MEMORANDUM

FILE NO.: SMP2012 0002

PROPOSAL: A Major Subdivision resulting in five new parcels along Mendenhall Loop Road near Auke Lake.

PLAT OF
AUKE LAKE RIDGE SUBDIVISION
A SUBDIVISION OF
LOT Y,
WITHIN U.S. SURVEY NO. 2391
CITY & BOROUGH OF JUNEAU, ALASKA
JUNEAU RECORDING DISTRICT

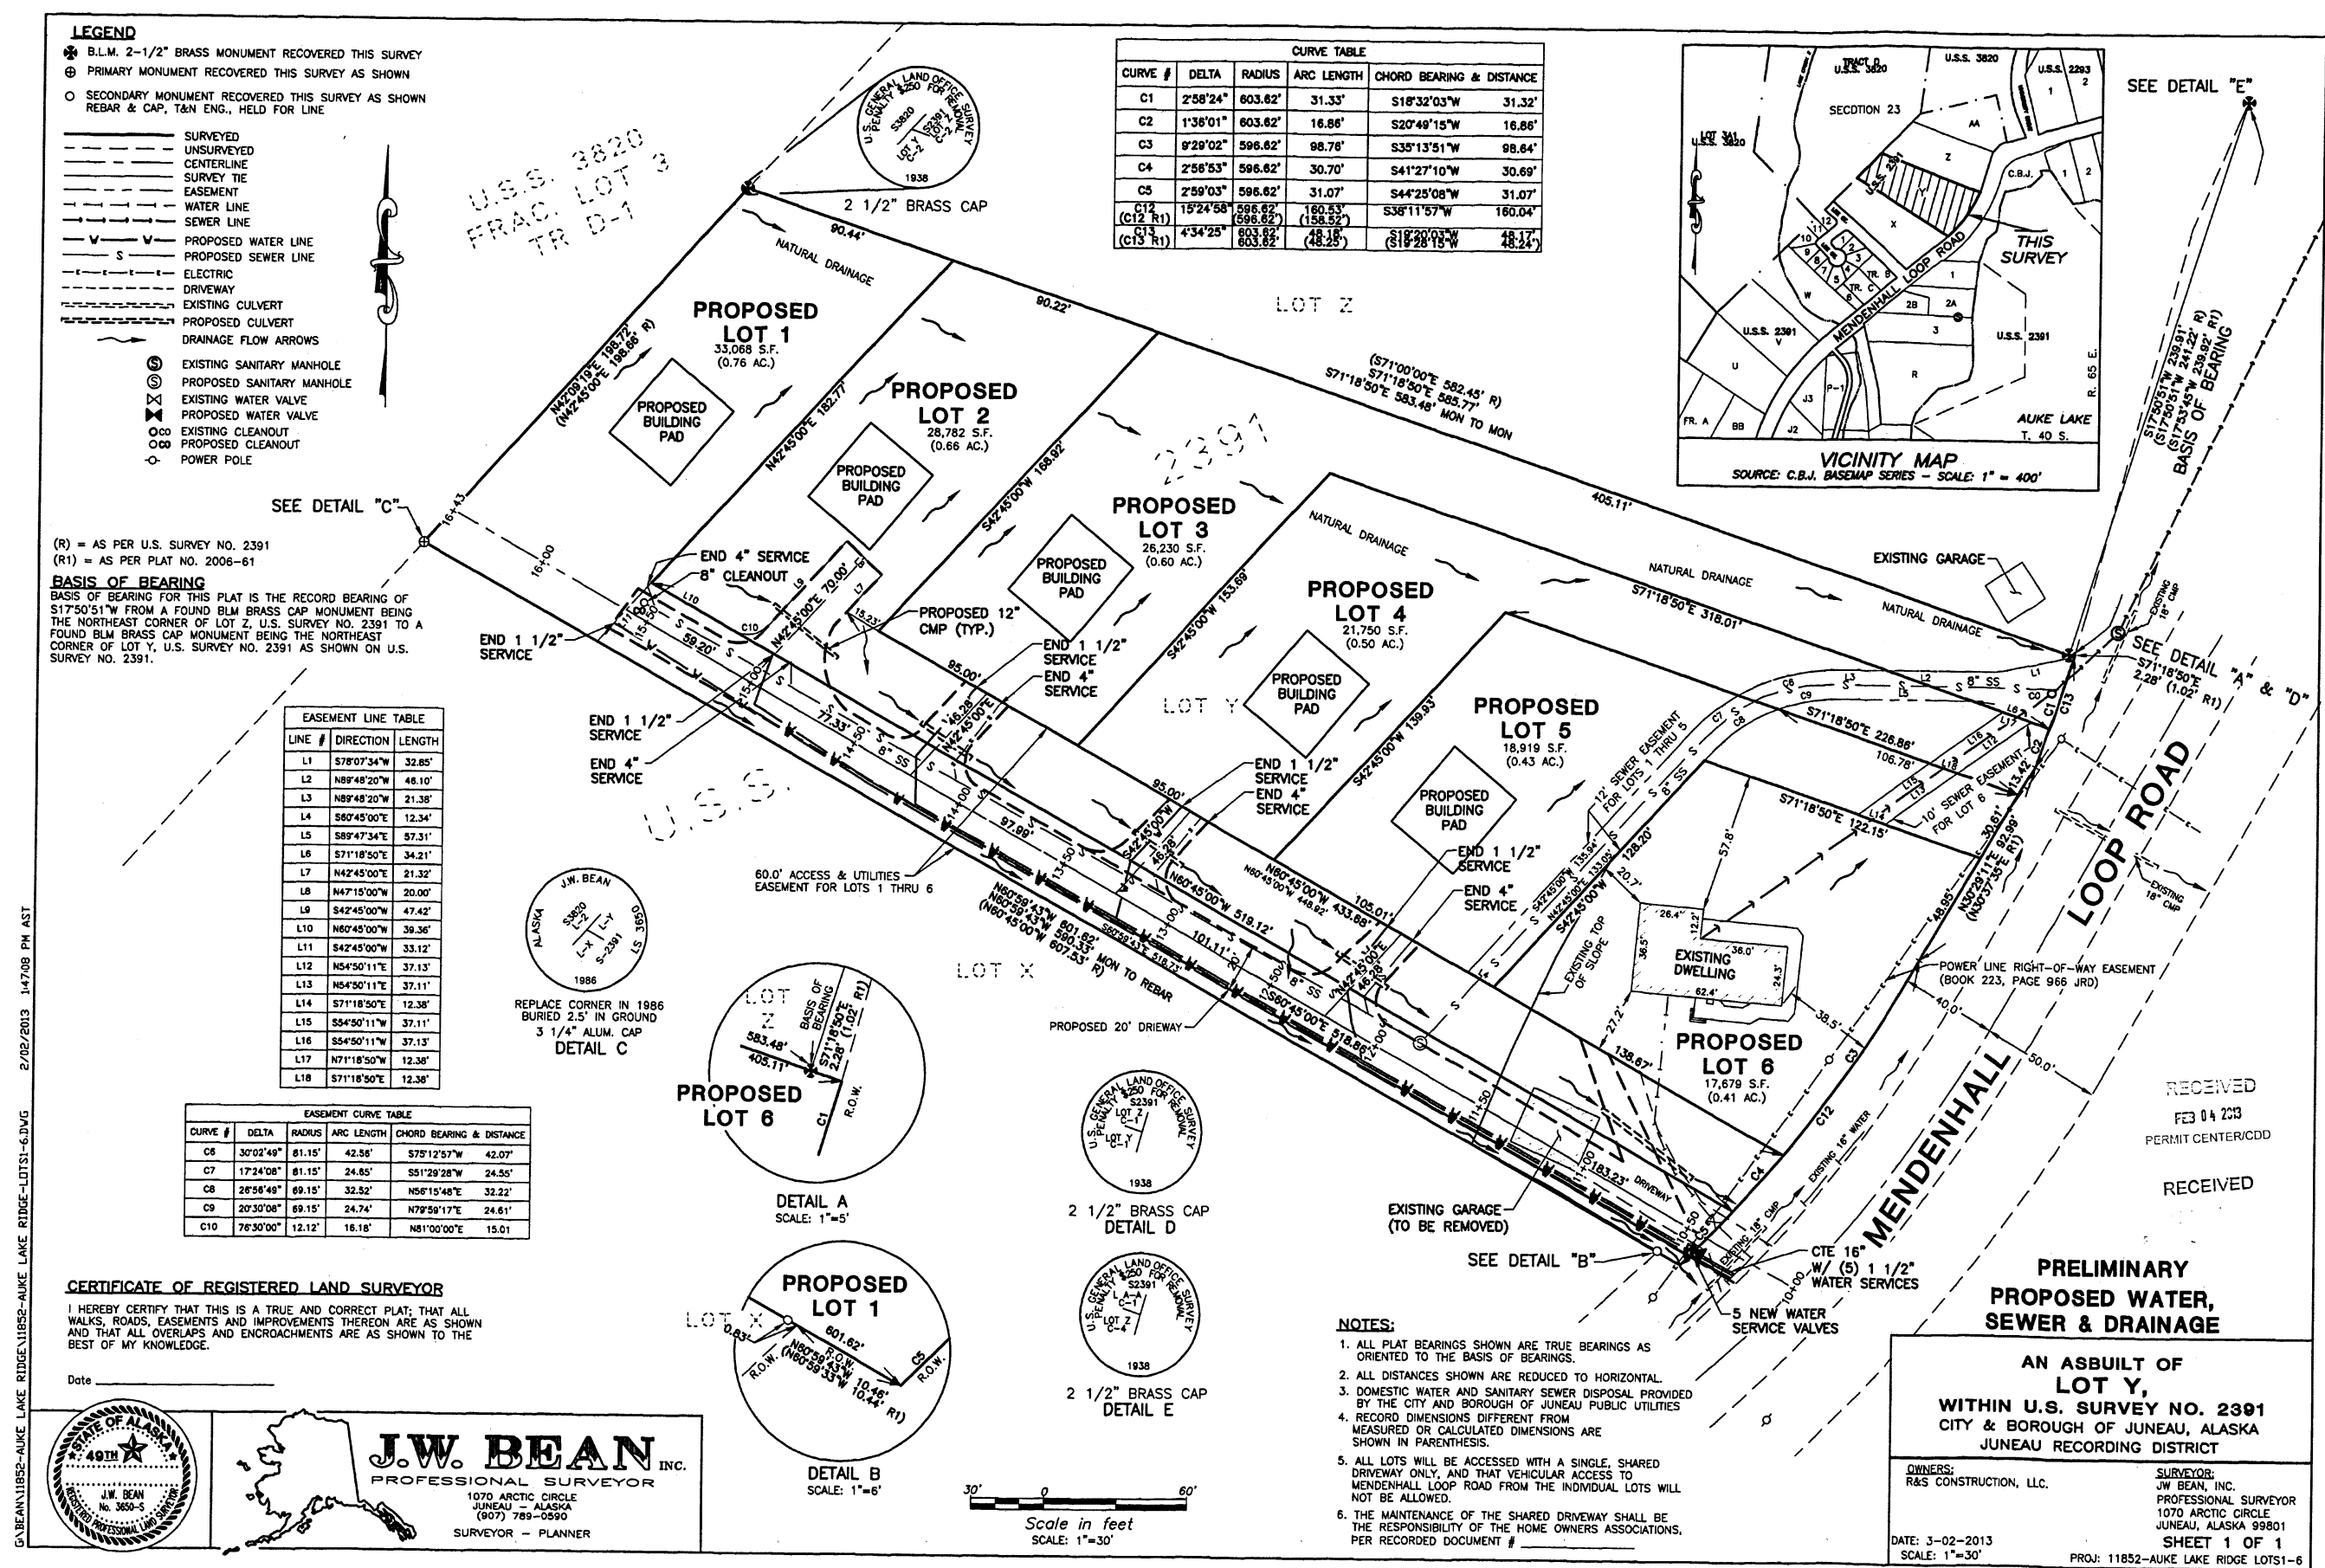
This is met under Attachment B. Items (B) (i – v) are all shown on Attachment B. The address of the owner is not shown in the title block. Staff recommends this be added as a condition of Final Plat approval.

Since many of the lot's drainages are shown to be crossing adjacent lots within the subdivision, the applicant shall establish drainage easements wherever this is anticipated to occur. Staff recommends the applicant show Drainage Easements as a condition of Preliminary Plat approval.

A ten foot drainage and no disturbance easement shall be shown along the entire northeast border of the subdivision. This will allow for a natural filtration of stormwater runoff prior to entering the 18" cross culvert on Back Loop.

“We would request a plat note stating that no future access from lots 2,3,4,5 & 6 Back Loop Road be allowed.”

This is not shown in the applicant's submittals; therefore, staff recommends the submittal of this element be a condition of Preliminary Plat approval.

This comment has been addressed under plat Note 5 on Attachment B.

2. Prior to Final Plat approval, the applicant shall designate all wetlands on the plat derived from a wetland delineation.
3. Prior to the recording of the subdivision plat, the applicant shall remove, or bond for the removal of, the garage shown in Attachment C.

6. Prior to Final Plat Approval, the applicant shall submit the results of a soils test to the Community Development Department.
7. Prior to Final Plat Approval, the applicant shall add the address of the owner in the Plat title block.

11. Prior to Final Plat approval, the applicant shall designate on the plat a ten foot drainage and no disturbance easement along the entire northeast border of the subdivision. This will allow for a natural filtration of stormwater runoff prior to entering the 18" cross culvert on Back Loop Road.

A PLAN & PROFILE OF
20' WIDE DRIVEWAY
FOR
LOT Y,
WITHIN U.S. SURVEY NO. 2391
CITY & BOROUGH OF JUNEAU, ALASKA
JUNEAU RECORDING DISTRICT

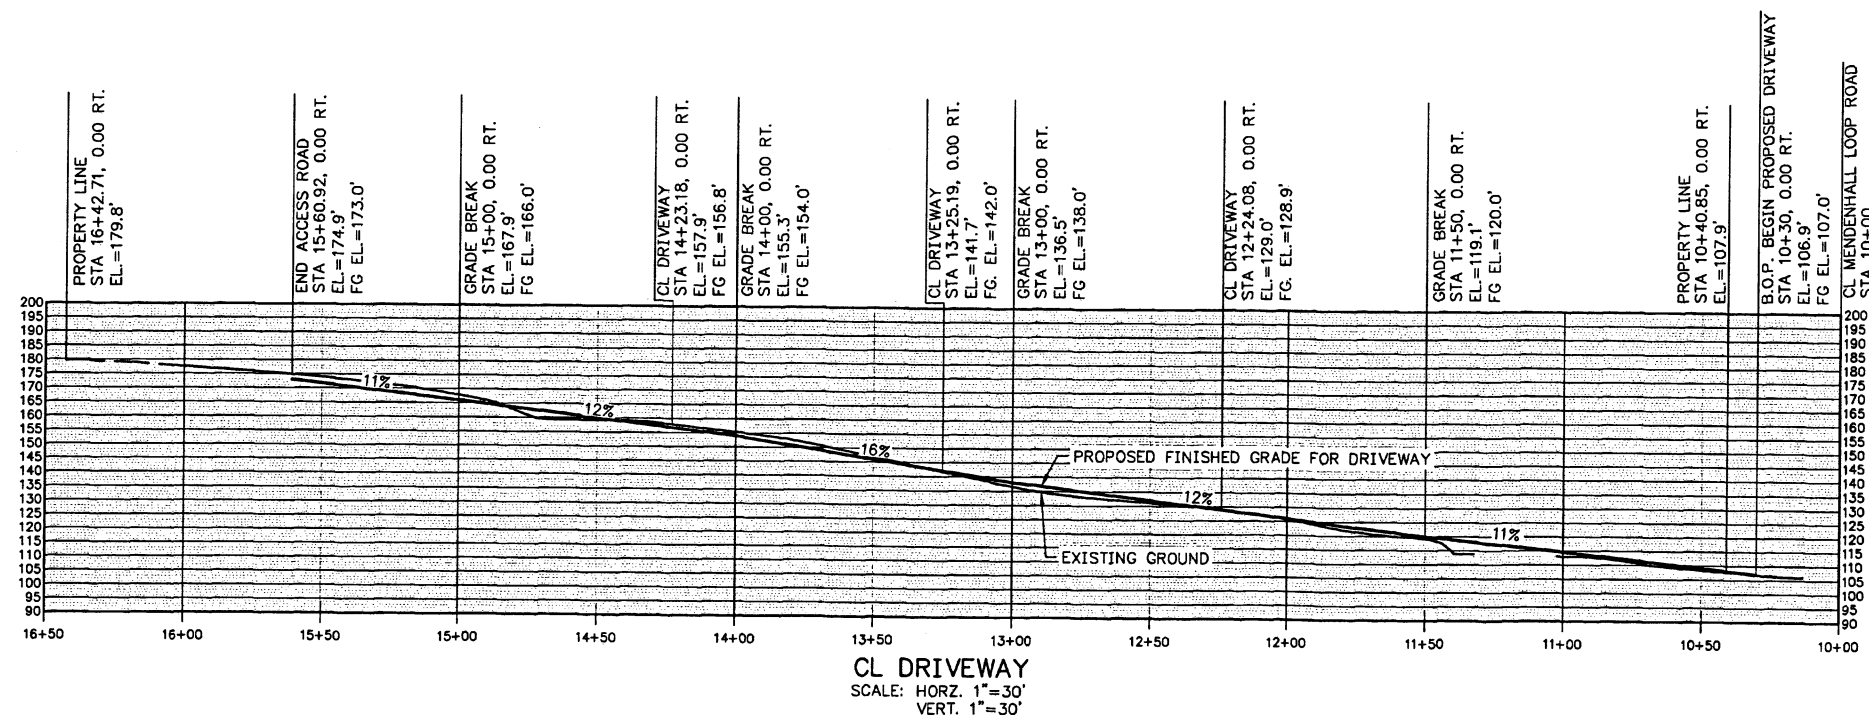
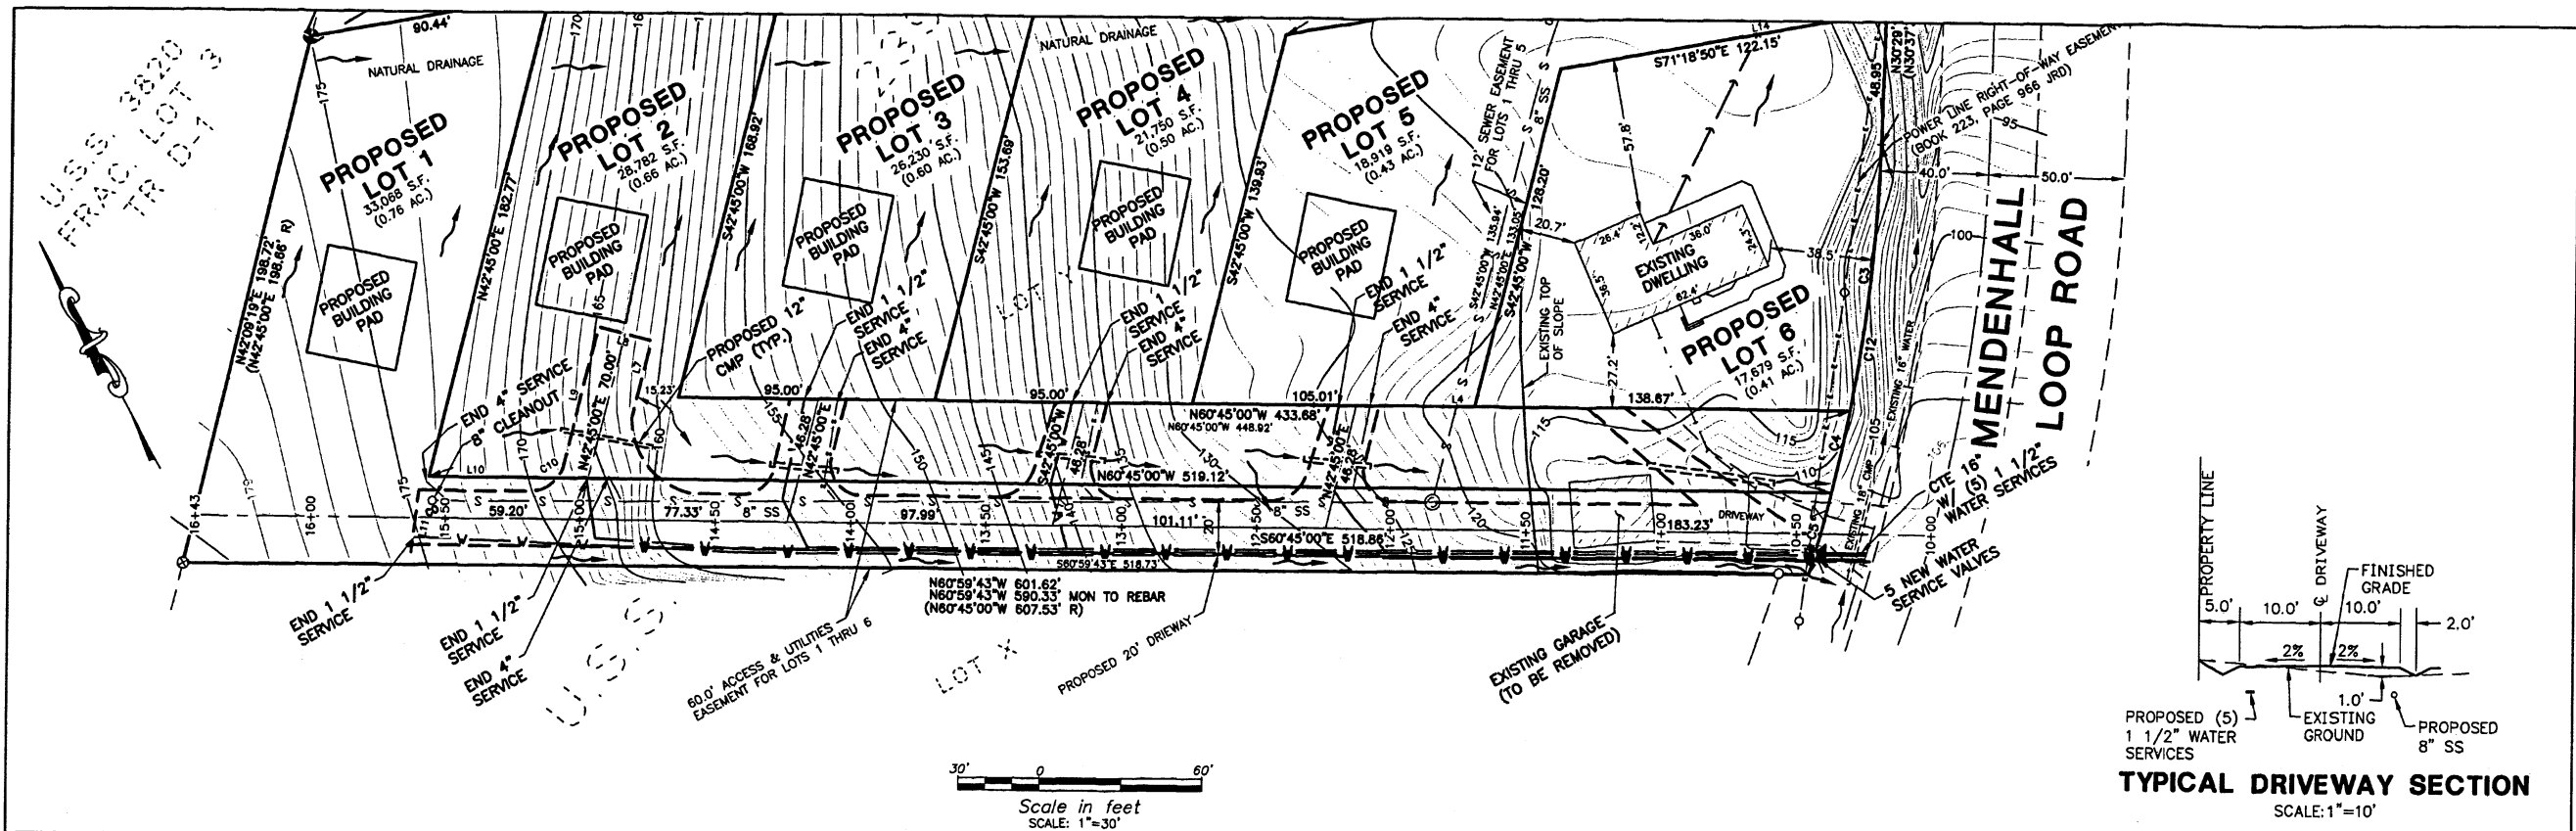
Attachment C shows drainage features along the new driveway and general surface drainage from each lot. Drainage is shown to be generally flowing toward a surface ditch along Mendenhall Loop Road right-of-way.

The applicant shall make a note on the construction drawings stating: The centerline of the driveway shall meander to match the flowline of the ditch to the toe of existing slope. This will maintain the integrity of the existing slope. In addition the ditch shall be widened to 8ft to allow for a bioswale meeting the intention of the CBJ Stormwater Program.

Attachment C shows the proposed driveway having slopes exceeding 5%. Though the contour lines are one-foot intervals this is not noted on the plans. Staff recommends the contour interval be noted on the plans as a condition of Preliminary Plat approval.

The applicant has noted that the garage shown in Attachment C will be removed for the proposed subdivision. Since this garage will overlay future property lines, the removal is required prior to the recording of the subdivision. Staff recommends the removal of the garage a condition of Preliminary Plat approval.

9. Prior to construction, the applicant shall note the contour interval on a topographic plan for Community Development Department acceptance.

12. Prior to construction approval, the applicant shall make a note on the construction drawings stating: The centerline of the driveway shall meander to match the flowline of the ditch to the toe of existing slope. This will maintain the integrity of the existing slope. In addition, the ditch shall be widened to 8ft to allow for a bioswale meeting the intention of the CBJ Stormwater Program.
